Subject: Agenda Item for the June 12, 2022 Plan Commission Meeting

Approving a Planned Development - Specific Implementation Plan (SIP) at 51 West, Lot 1, 2900 – 3020 Blue Grass Drive, Stoughton, WI.

SPECIFIC IMPLEMENTATION PLAN

BLUE GRASS DRIVE DUPLEXES

SITE PLAN

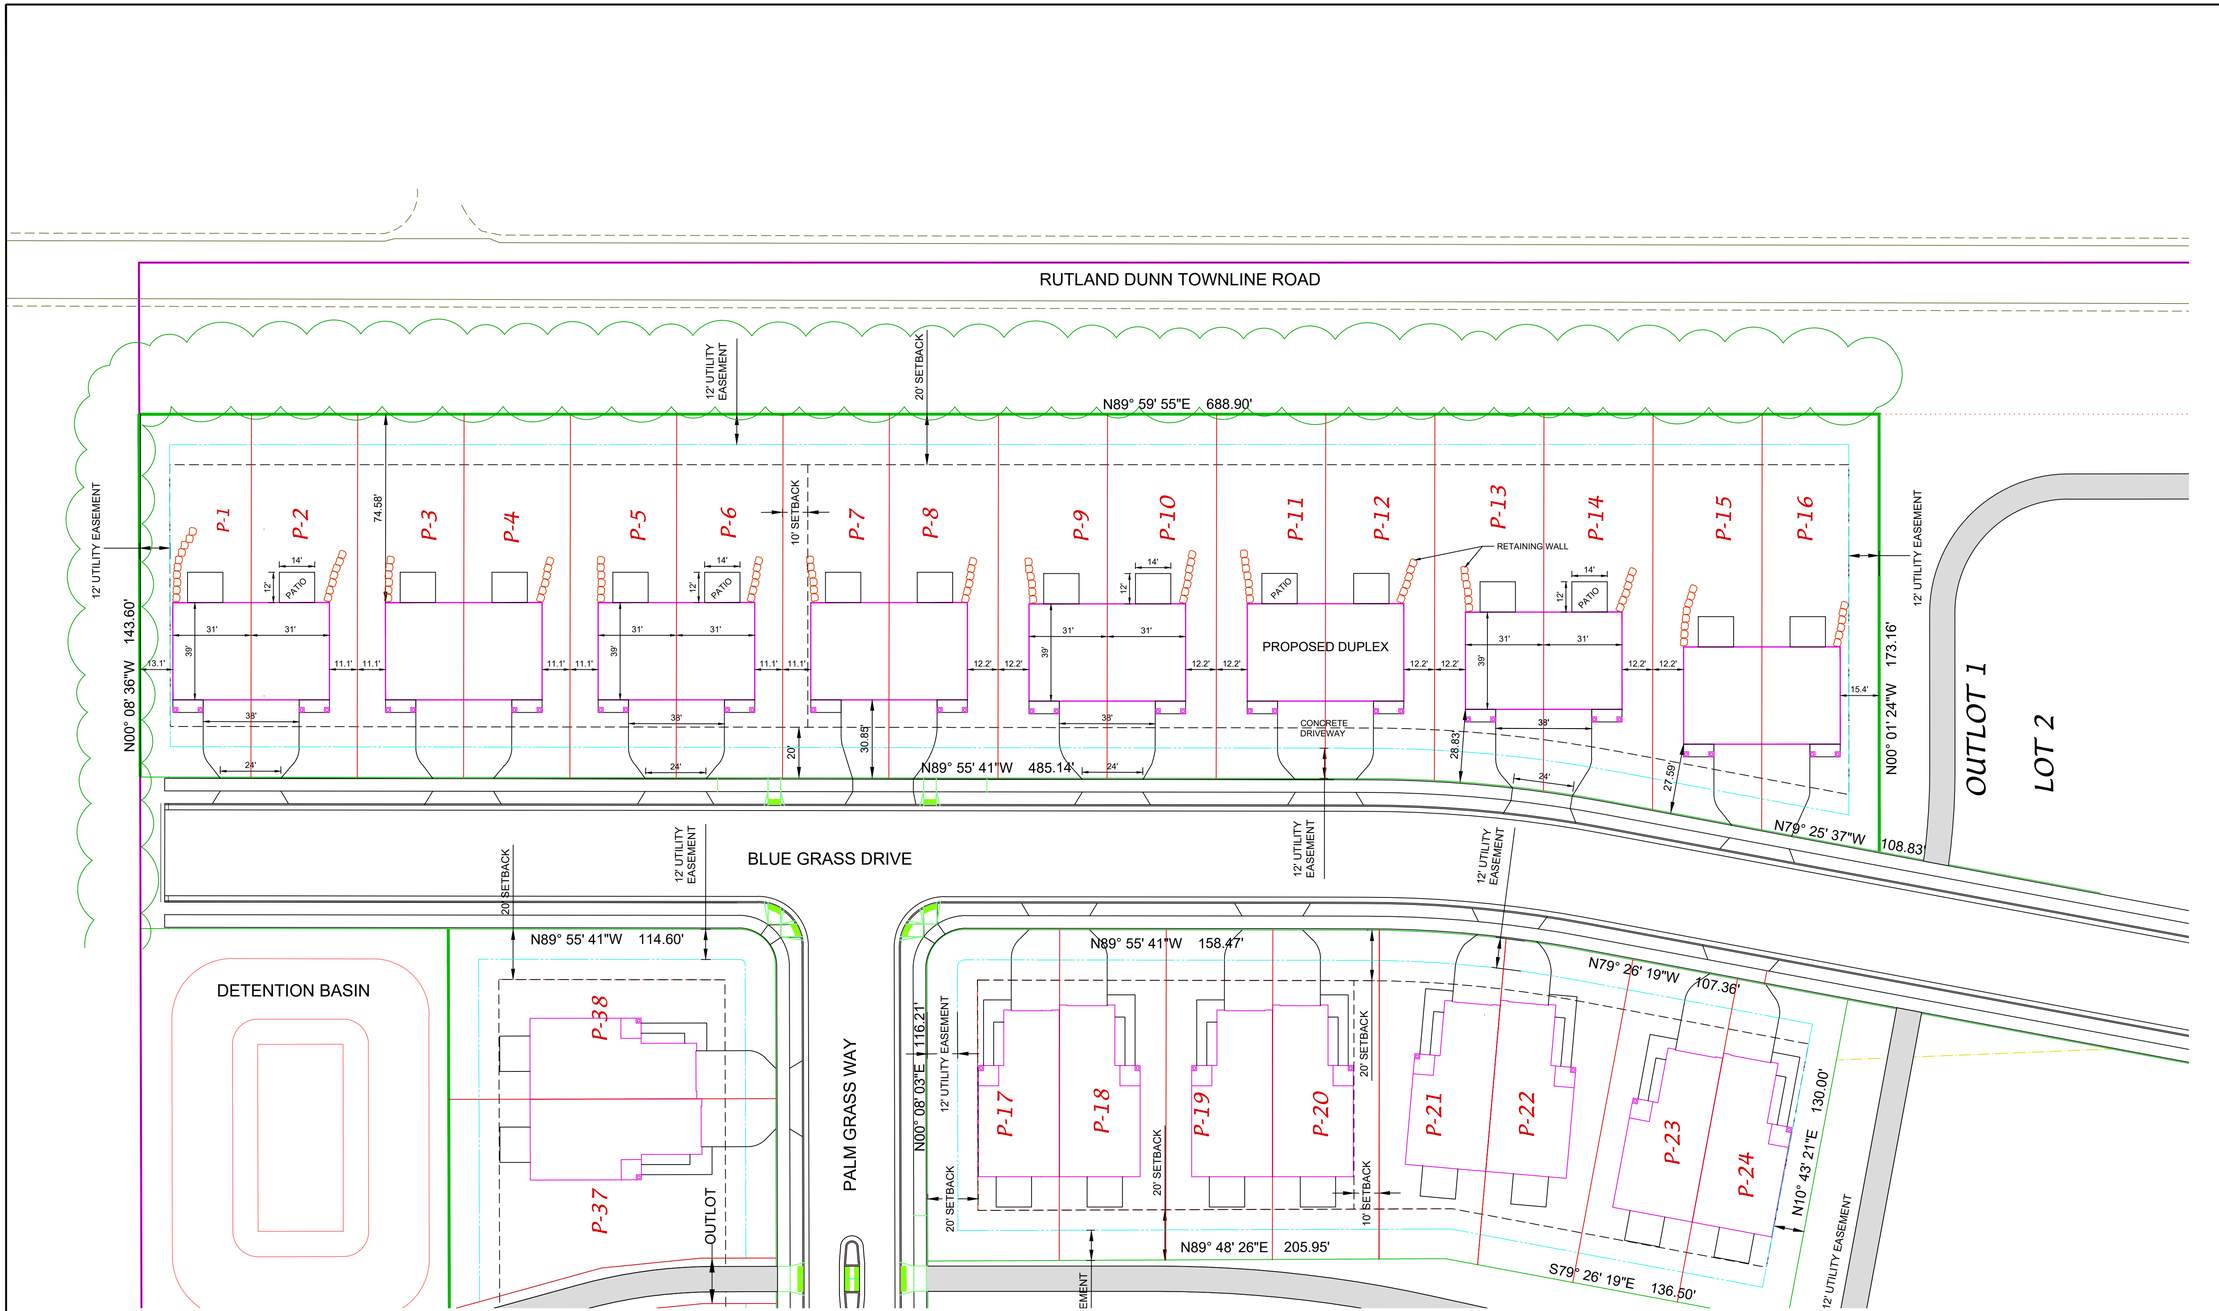
1. The minimum lot area requirement is 5,000 square feet per dwelling unit. **The plan meets this requirement.**

3. The district requires a minimum front or street side lot line setback of 20 feet. **The plan complies with this requirement.**

4. The district requires a minimum side lot line setback of 10 feet. **The plan complies with this requirement.**

9. The parking requirement for the district is as follows including garage spaces: 2 spaces per lot. **The plan meets this requirement.**

12. Public sidewalk is required along all public frontages and shall be delineated on the site plan. Sidewalk shall be 5 feet wide and a minimum of 6" through driveways and a minimum of 5" thick otherwise. **Expected**

14. All curb openings for access drives shall have a maximum width of 24 feet for residential uses, as measured at the right-of-way line. Access drives may be flared between the right-of-way line and the roadway up to a maximum of five additional feet and may be exceeded with explicit Plan Commission approval. **The plan meets this requirement.**

18. Proposed utilities-including electrical transformers locations shall be shown on the plan. **Contact Stoughton Utilities for electric, water and wastewater services.**

LANDSCAPE PLAN

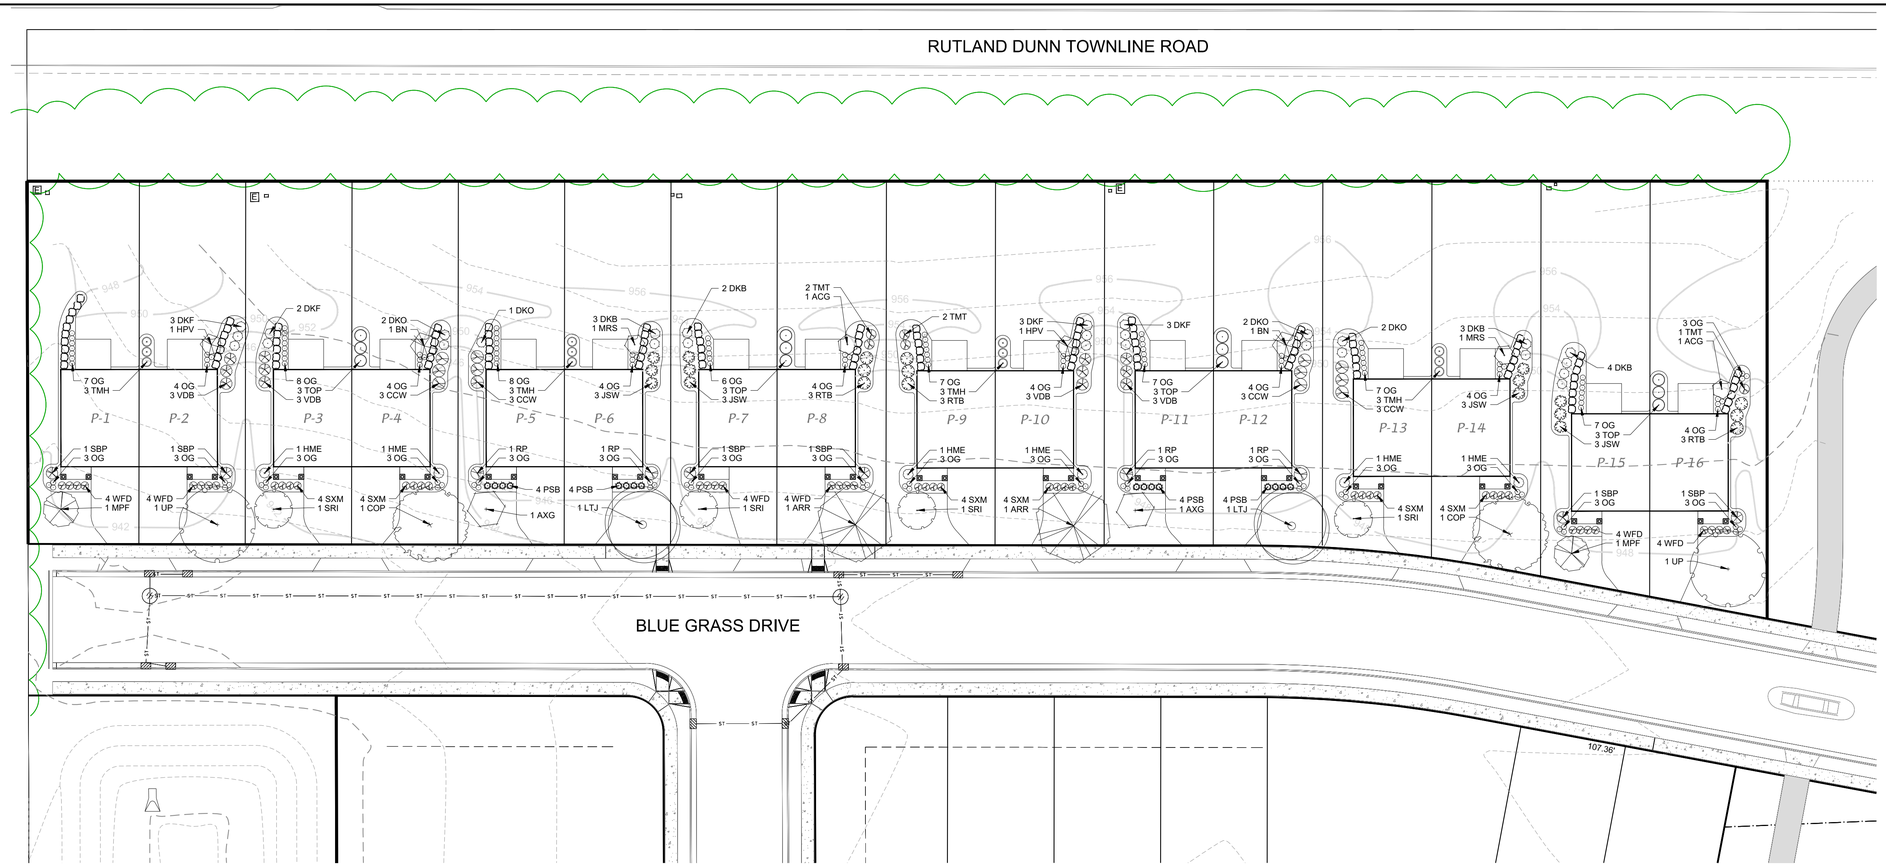
16. Terrace trees are required according to section 10-2(d). An application will need to be filed with the Department of Planning and Development. All terrace trees shall be taken care of prior to permit issuance. **For questions related to terrace trees, contact Brett Hebert, Public Works Director at 608-873-6303 or bhebert@ci.stoughton.wi.us**
